ADDENDUM NO. 4

CITY OF SAN ANTONIO TRANSPORTATION & CAPITAL IMPROVEMENTS

PROJECT NAME: **REDLAND ROAD SOUTH (1604 TO JONES MALTSBERGER)**

TCI PROJECT NO.: **40-00313**

TREE PRESERVATION PLAN
 STA 22+00 TO STA 26+00

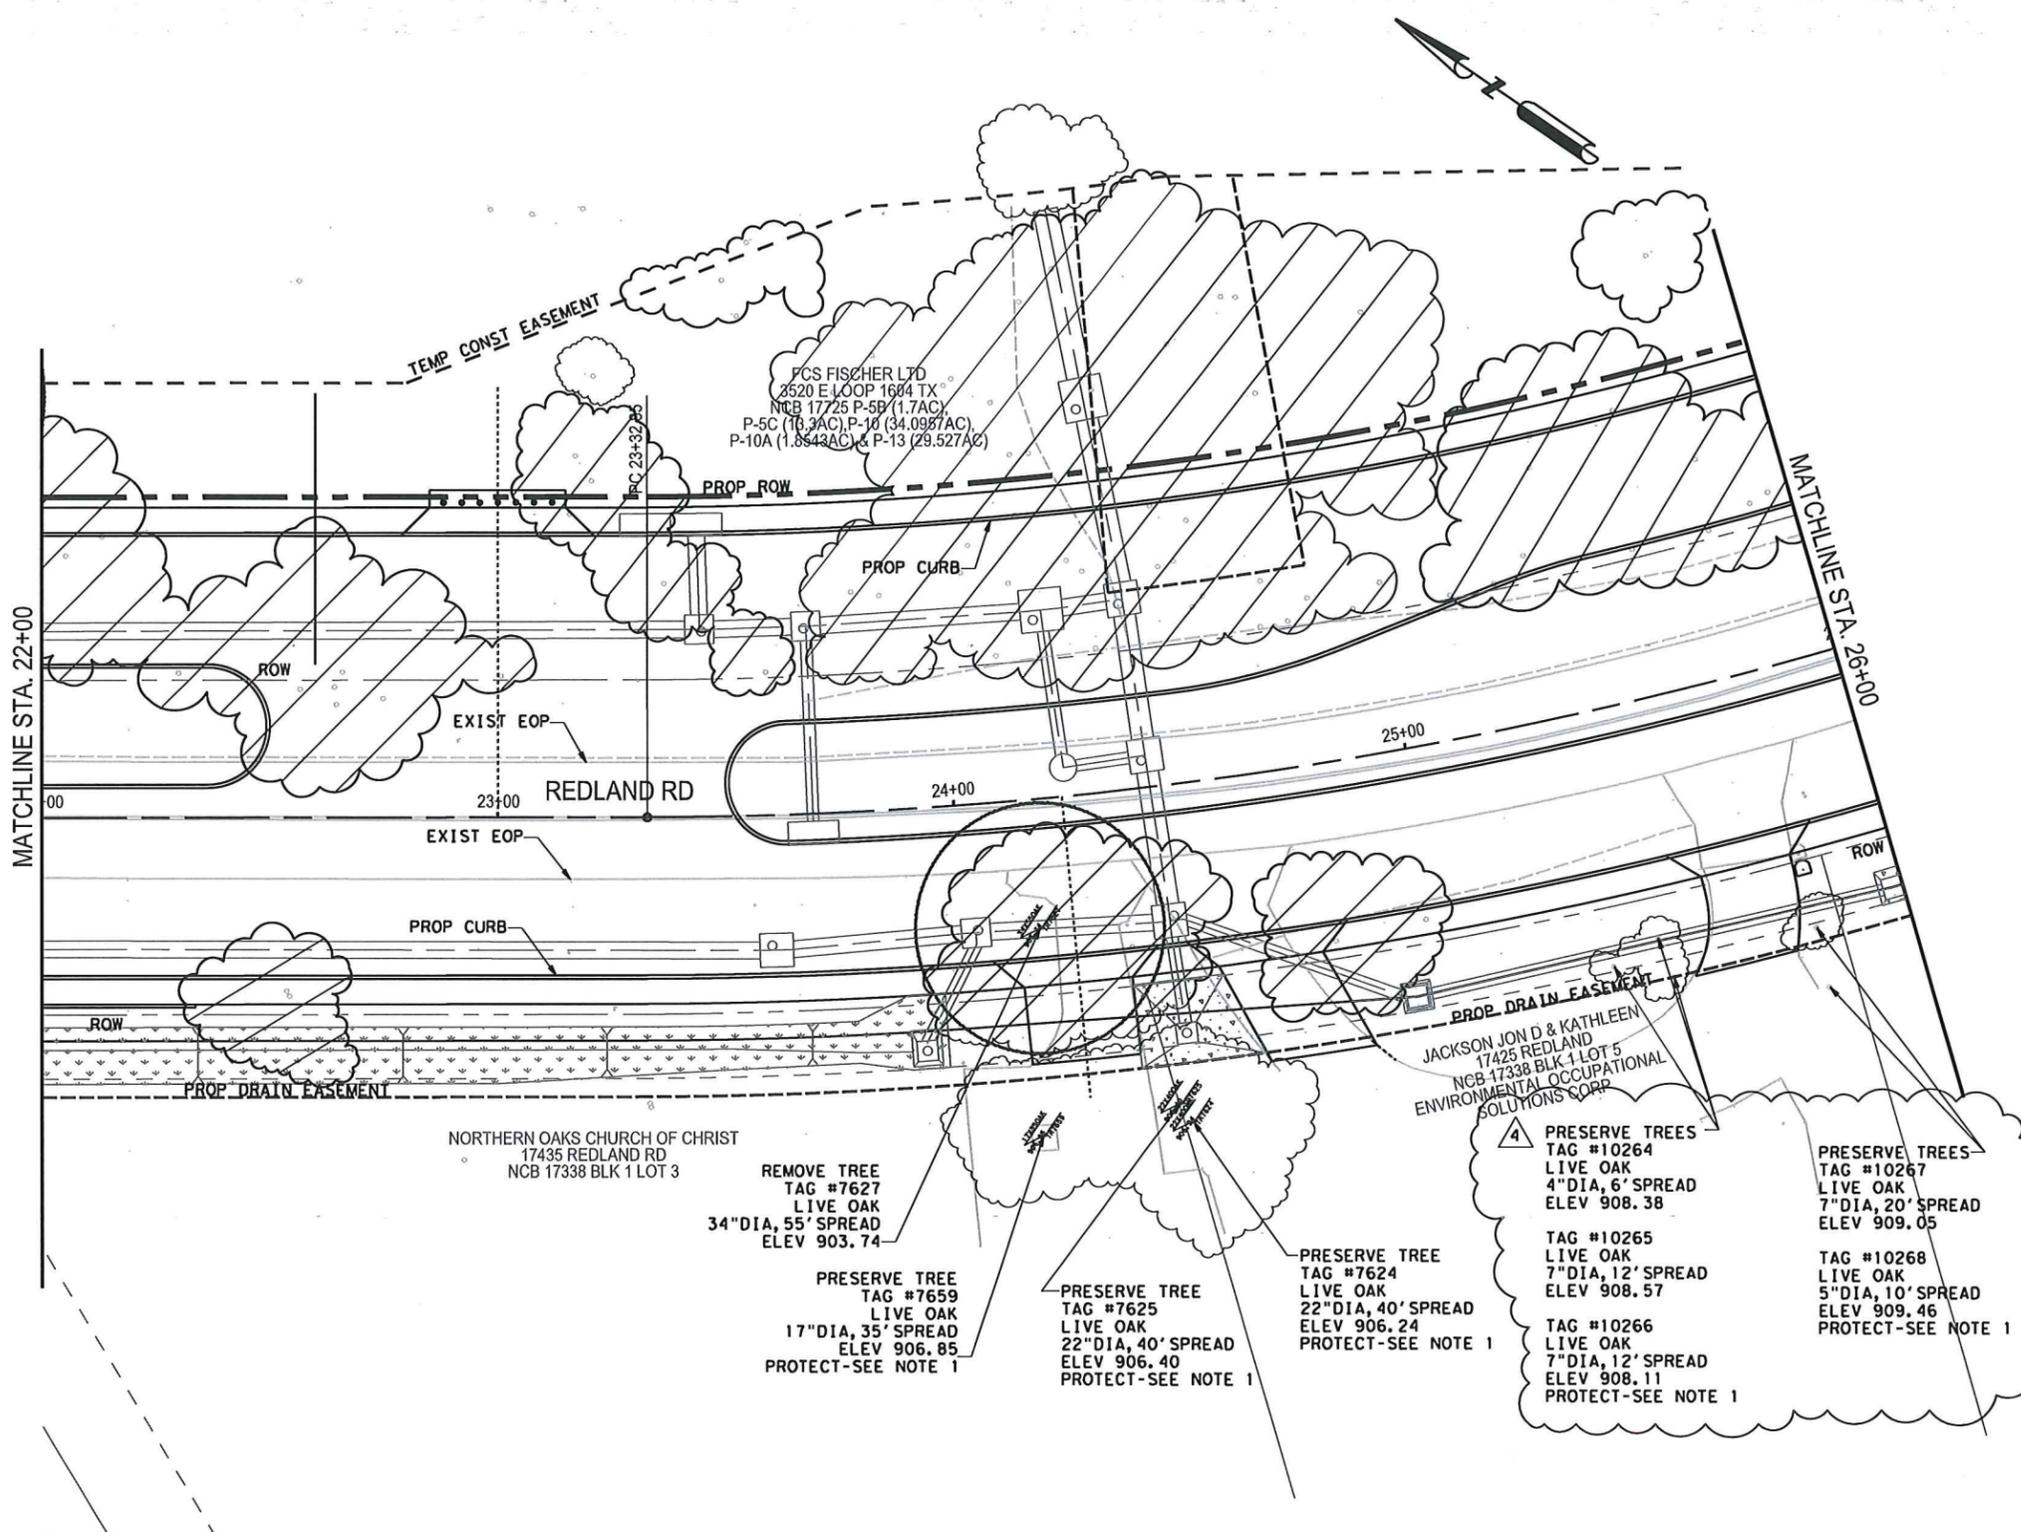
1. Substitute and utilize "ROADWAY SUMMARY" (Sheet No. 18)
 - a. Revised quantities for Item 6004 Utility Pole Bracing
2. Substitute and utilize "ESTIMATED QUANTITIES" (Sheet No. 14)
 - a. Revised quantities for Item 6004 Utility Pole Bracing under Redland Road COSA Items
 - b. Added Item 6004 under Jones Maltsberger Base Bid and quantities Item 6004
3. Substitute and utilize "TREE PRESERVATION PLAN" (Sheet No. 190)
 - a. Added preservation notes at Jackson lot adjacent to driveway located at approximately Station 25+75.00.
